Access Compliance Report Public Rights-of-Way (Curb Ramps)

Main Street: WASHINGTON_AVE		Cross Street: EARLHAM_ST		Location:	NW
ADA ID: RPAT210929144747	Ramp Type: Type 4 - Parallel	Initial Pass/Fail: Fail	Overall Compliance: No	Severity Score:	5
Codes/Mitigation Info/Possible Solution			Field Measurements/Component Compliance

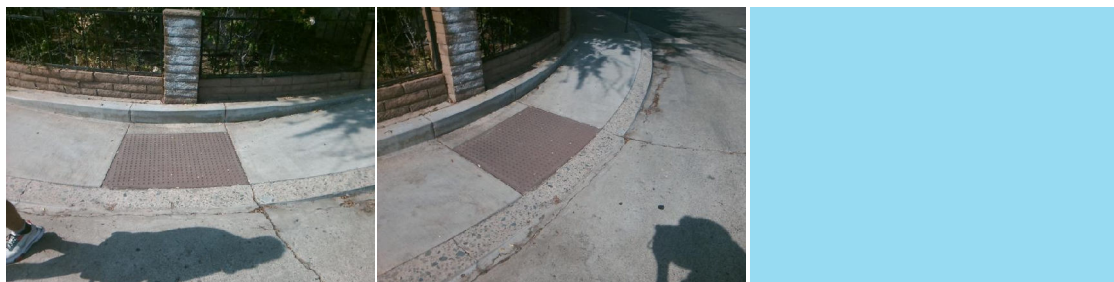
R304.5.1, R304.5.3, STD 122-2, STD 1115

Remove & Replace Curb Ramp With Two New Directional Ramps or Equivalent. Replace Spandrel.
